Access Compliance Report Public Rights-of-Way (Curb Ramps)

Main Street: DUNAS_RD Cross Street: ROMELLE_AVE Location: NE

ADA ID: RPAT211005100343 Ramp Type: Type 1 - Perpendicular Diagonal Initial Pass/Fail: Fail Overall Compliance: No Severity Score: 16

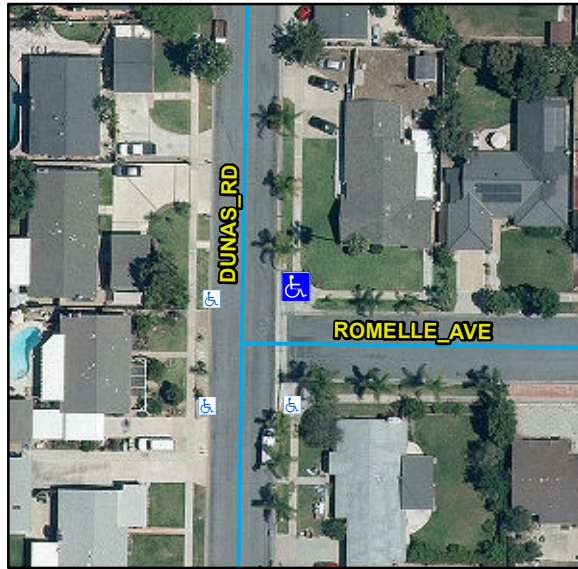
Compliance	Description	Data	Compliance	Description	Data
N/A	Ramp Length (in)	129	N/A	Flare Type LT	
Yes	Ramp Width (in)	51			N/A
No	Ramp Run Slope (%)	8.4	N/A	Flare Slope LT (%)	N/A
Yes	Ramp Cross Slope (%)	1	N/A	Flare Traversable LT	N/A
N/A	Landing Present	N/A	N/A	Flare Type RT	
N/A	Landing Length (in)	N/A			N/A
N/A	Landing Width (in)	N/A	N/A	Flare Slope RT (%)	N/A
N/A	Landing Run Slope (%)	N/A	N/A	Flare Traversable RT	N/A
N/A	Landing Cross Slope (%)	N/A	N/A	DWS Provided	N/A
N/A	Landing Movement Obstructed?	N/A	N/A	DWS Contrast	N/A
	Landing Movement Type	N/A	N/A	DWS Length (in)	N/A
N/A	Landing Shared	N/A	N/A	DWS Full Width	N/A
N/A	Clear Space	Yes	N/A	DWS Offset Left (in)	N/A
N/A	Clear Space To Crosswalk (in)	N/A	N/A	DWS Offset Right (in)	N/A
N/A	Marked Crosswalk 1	No	N/A	Marked Crosswalk 2	No
	Crossing 1 Direction	W		Crossing 2 Direction	S
	Marked Crosswalk 1 Width (in)	N/A		Marked Crosswalk 2 Width (in)	N/A

N/A	Ramp Inside Crosswalk 1	N/A	Yes	Ramp Inside Crosswalk 2	N/A
	Crossing 1 Slope (%)	2.2		Crossing 2 Slope (%)	1
	Crossing 1 Cross Slope (%)	1.4		Crossing 2 Cross Slope (%)	2
N/A	Gutter Ponding	N/A	No	Curb Slope	8.2
Yes	Gutter Lip Height (in)	0		Road Run Slope (%)	0.7
N/A	Gutter Run Slope (%)	N/A		Road Cross Slope (%)	1.5
N/A	Gutter Cross Slope (%)	N/A			
Yes	Overall Surface Condition: Acceptable		Yes	Perp Joint Present	Yes
	Cross Gutter Present?	Yes		Spandrel Present?	Yes
	Replace Cross Gutter?	No		Replace Spandrel?	No

Remove & Replace Curb Ramp With Two New Directional Ramps or Equivalent.

R304.2.2, STD 1115
